Thomas McLaughlin - NRC EA for JPG

From: "Cloud, Paul D RDECOM" <paul.d.cloud@us.army.mil>
To: "Thomas McLaughlin" <TGM@nrc.gov>
Date: 03/30/2006 9:48 AM
Subject: NRC EA for JPG
CC: "Kuykendall, Joyce E ECBC" <joyce.kuykendall@us.army.mil>

Figure 1-2. Potential Public Use of Big Oaks National Wildlife Refuge

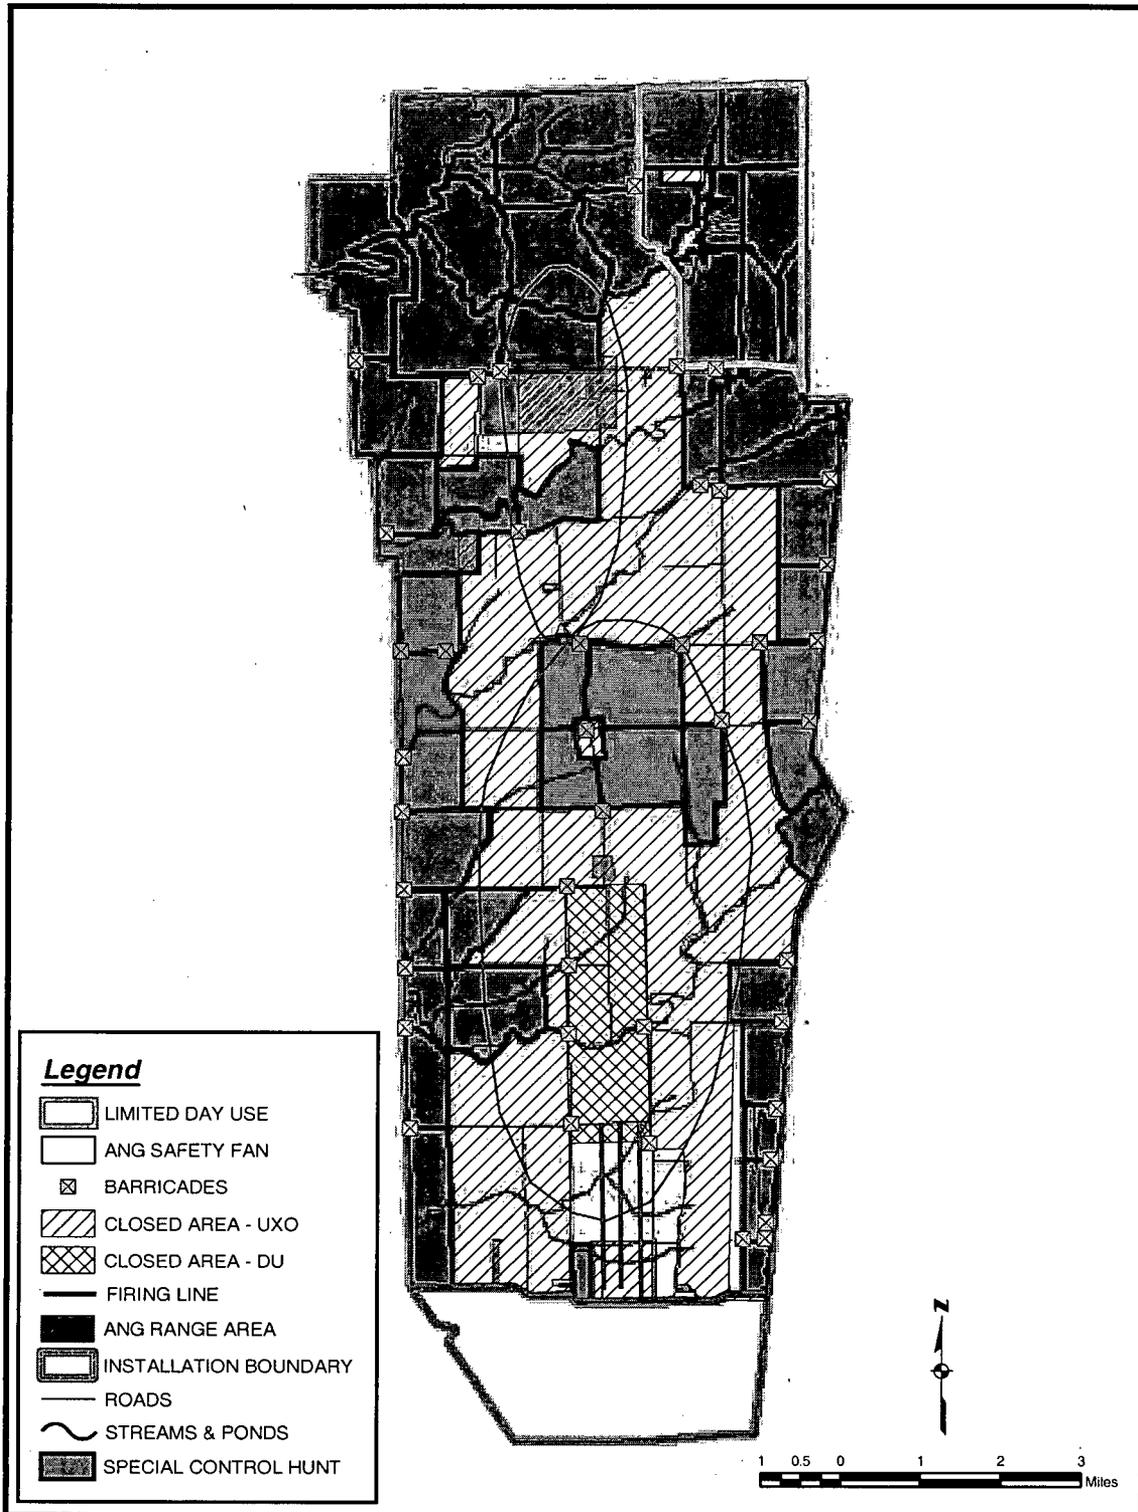
Tom: A heads up regarding the NRC EA for the JPG requested alternate decommissioning schedule. In the EA, in the first paragraph of the "Introduction" section, second sentence, the distance from the DU area to the western boundary of the facility is stated as "2 kilometers", this distance is actually "2 Miles" which is actually 3.2 kilometers. See the attached map from the 2002 Environmental Report the Army submitted to NRC for confirmation. If you have any questions please let me know.
